## Customer Service Bulletin Commercial Business Group

### Reelmaster® 335/3500/6500/6700-D and Groundsmaster® 455-D

**Subject: Hydraulic oil leaks past Motor Seal into 4wd Rear Axle.**

**Adapter Sleeve Assembly**

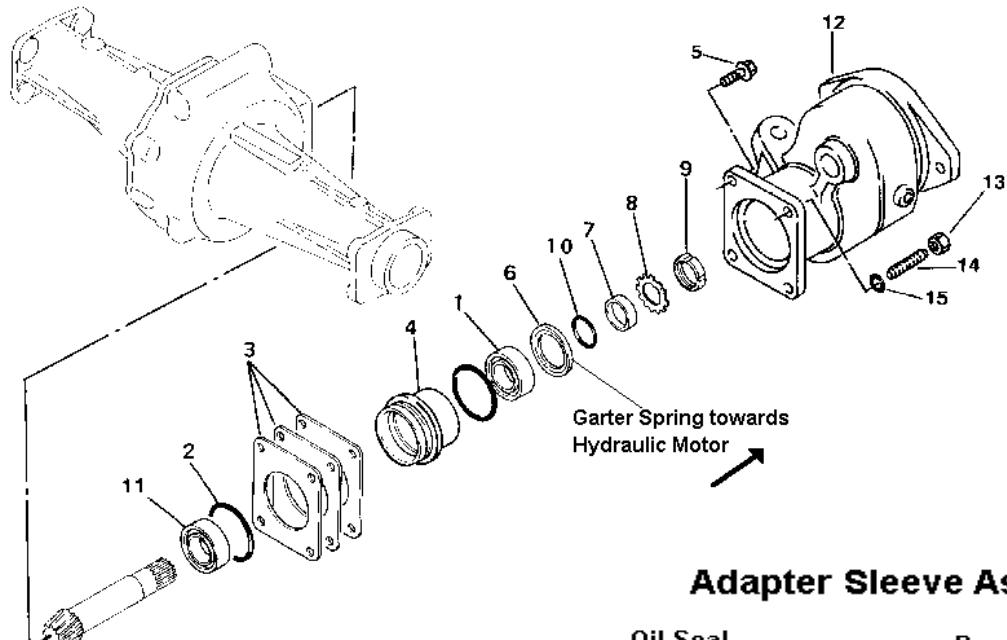
When installing Traction Drive Motor Seal (76-7340), be certain that it is positioned properly to prevent oil from entering the Axle. The Service Manual diagrams for proper Seal installation are vague. If this Seal is installed improperly, repetitive failures can result.

A revised diagram detailing proper parts and Seal orientation is shown below for your reference. Copies of this diagram are recommended to be inserted into all affected Service Manuals (Reelmaster 335/3500-D, 6500/6700-D and Groundsmaster 455-D) in section 6 - Axles and Brakes.
